HIGHLAND SPRINGS 2ND ADDITION

S/D 99-29 -- Final Plat of HIGHLAND SPRINGS SECOND ADDITION

S/D 99-29 -- Final Plat of HIGHLAND SPRINGS SECOND ADDITION

CASE NUMBER: S/D 99-29 - HIGHLAND SPRINGS 2ND ADDITION

HIGHLAND SPRINGS 2ND ADDITION

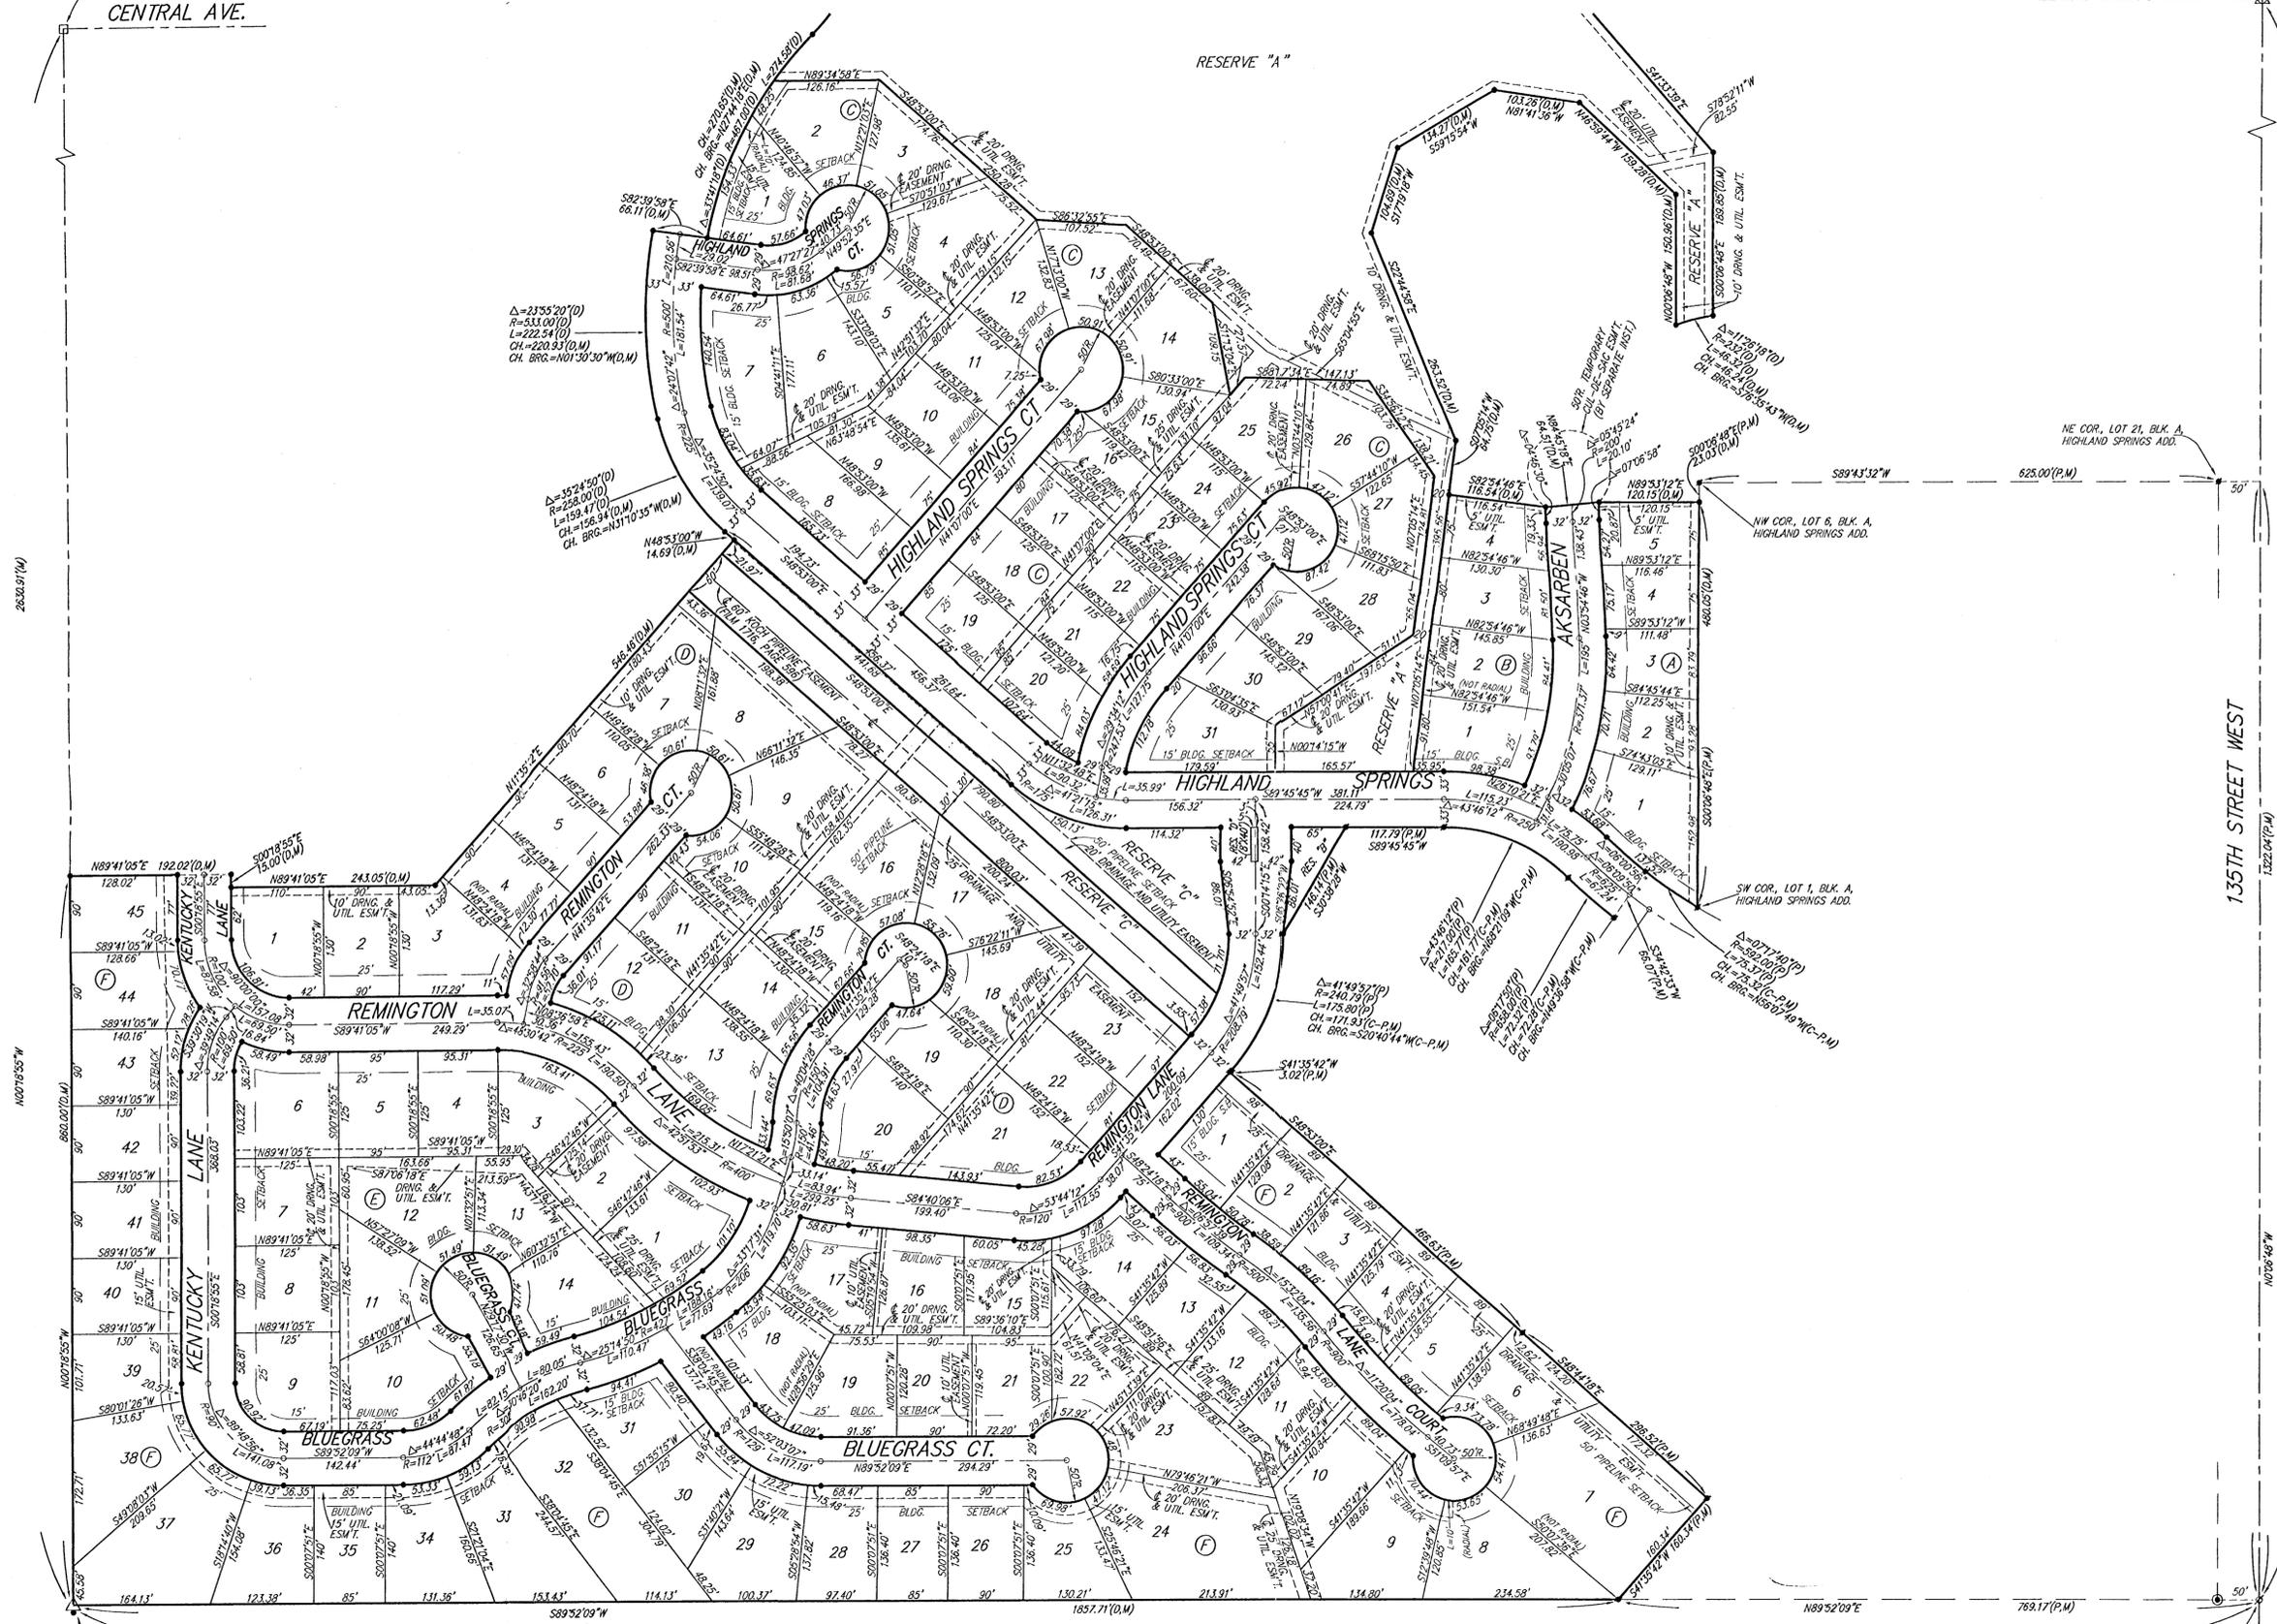
- A. The site is located within the Northwest Wichita sewer growth limits. The applicant shall guarantee the extension of sanitary sewer and City water to serve the lots being platted.

- C. City Engineering needs to comment on the status of the applicant's drainage plan. **The drainage plan is approved. A guarantee is required.**
- D. The applicant shall guarantee the paving of the proposed interior streets. Highland Springs shall be paved to a collector street status, and sidewalks shall be guaranteed along both sides of the street. Sidewalks shall be guaranteed on one side of the non-cul-de-sac streets - Remington Lane, Kentucky Lane and Rolling Hills. A temporary turnaround for Rolling Hills shall be established by separate instrument.

- E. The applicant shall submit a copy of the instrument which establishes the pipeline easements on the property, which verifies that the easements shown are sufficient and that utilities may be located adjacent to and within the easements.

- F. The applicant's agent shall determine any setback requirements for the pipelines by researching the text of the pipeline agreements. If a setback from the pipeline easements is provided for in the pipeline easement agreements, it shall be indicated on the face of the plat.

- I. City Fire needs to comment on the acceptability of the street names. Several street names are not in compliance with the 12-character street name limitation. City Fire has requested that Rolling Hills be revised to Aksarben Street, Binter Circle be revised to Highland Springs Court, Remington Lane Court be revised to Remington Court. The east-west portion of Kentucky also needs to be revised to Bluegrass Street and Kentucky Lane Ct be revised to Bluegrass Court. Traffic Engineering has requested that Highland Springs be revised.

- J. For the swimming pool that the applicant intends for Reserve A, a site plan shall be submitted with the final tracing, for review and approval by the Director of Planning and the plattor's text needs to specify such a use for this reserve. This site plan shall provide the information indicated in the Subdivision Regulations. Otherwise a conditional use and public hearing will be needed in the future.

- N. The plattor's text shall include language that a drainage plan has been developed for the plat and that all drainage easements, rights-of-way, or reserves shall remain at established grades or as modified with the approval of the applicable City or County Engineer, and unobstructed to allow for the conveyance of stormwater.

- O. The minimum building opening elevations shall be designated in National Geodatic Vertical Datum (NGVD) and City Datum.
- P. Complete access control shall be dedicated along Central and referenced in the plattor's text.

- Q. To obtain a second point of access for fire vehicles, an emergency access easement shall be platted along the north line of the plat. No obstructions will be allowed in the easement except for any gates as is approved by the City Fire Department. The applicant shall also be responsible for the installation of an acceptable driving surface or other improvements as is determined by the City Fire Department.
